Reference: **1108 4th Avenue** Block: 1.63 Lot: 9

Thank you for your review of our drawings of the above referenced project. Per your action item list, the following changes have been made to the construction documents (three signed & sealed copies supplied here with).

RENOVATION / RE-BUILD
ESTATE OF DENNIS JAY HARKER
1108 4TH AVENUE, MANCHESTER TOWNSHIP
LOT: 9 BLOCK: 163

FIRST FLOOR PLAN
SCALE: 1/4" = 1'-0"

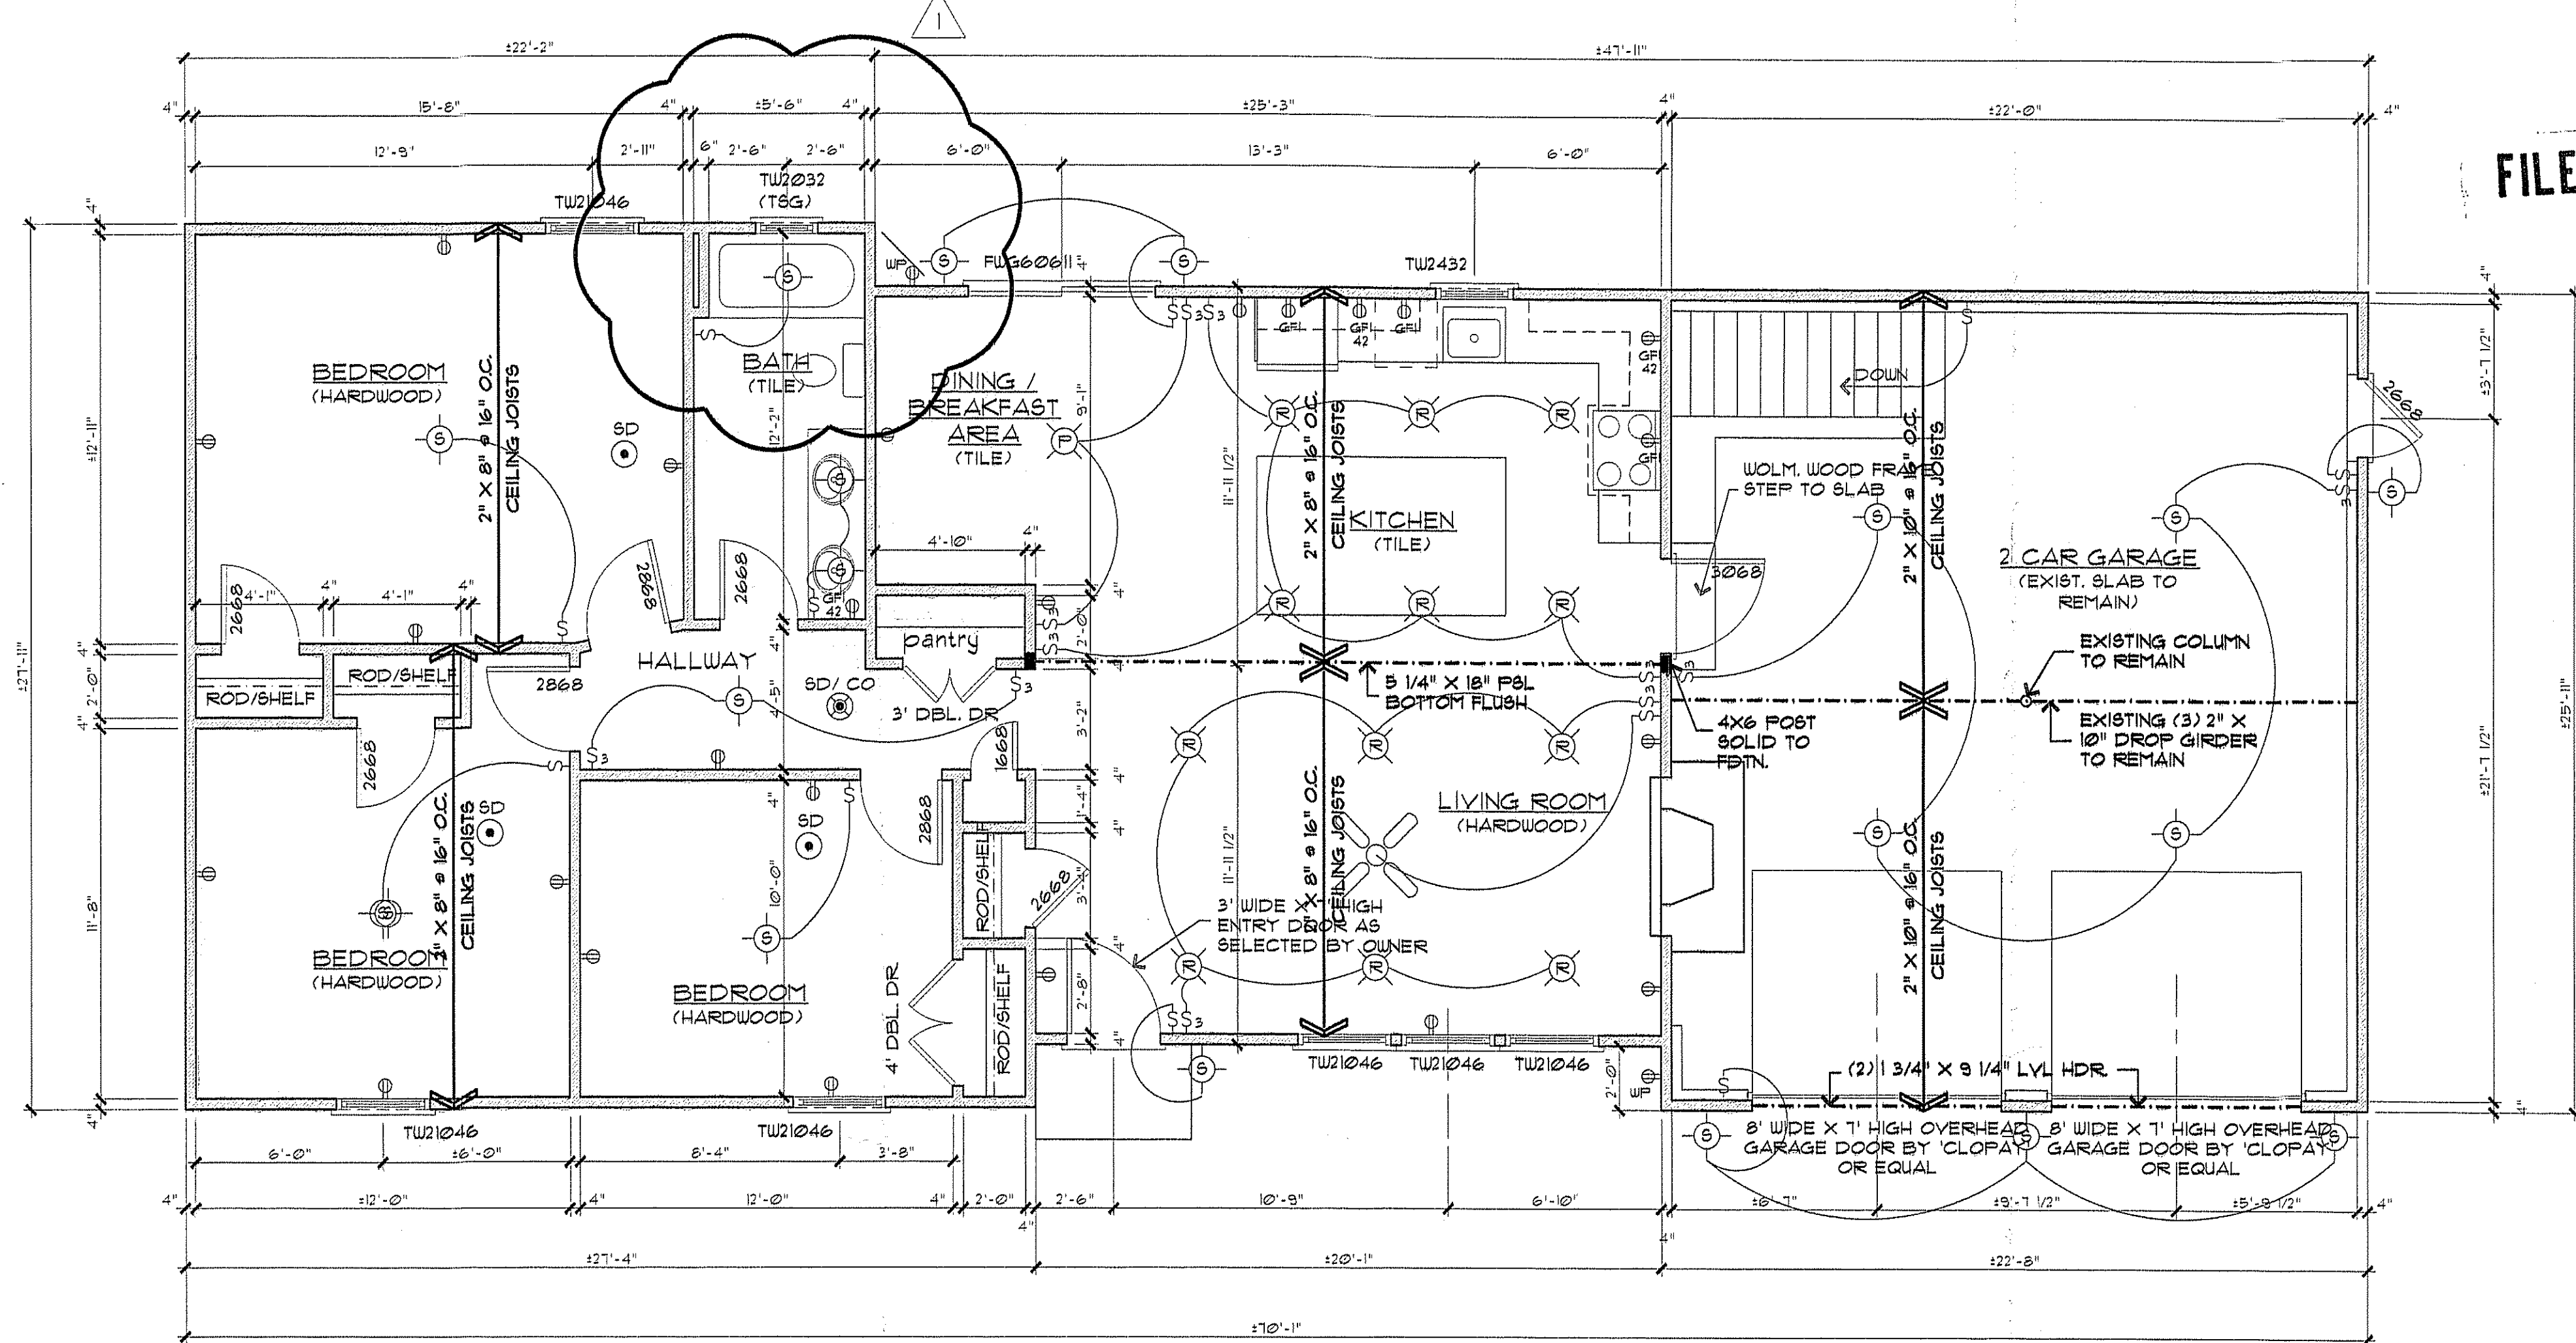
- The ResCheck Energy Code Calculations shown on the plans are revised under the 2018 energy code.
- The window above the bathroom tub is to be tempered safety glass.
- Contractor to follow up with revision to his building permit application to include the foundation repair work and addition of noted structure (parallam, column and footing) as per your email.
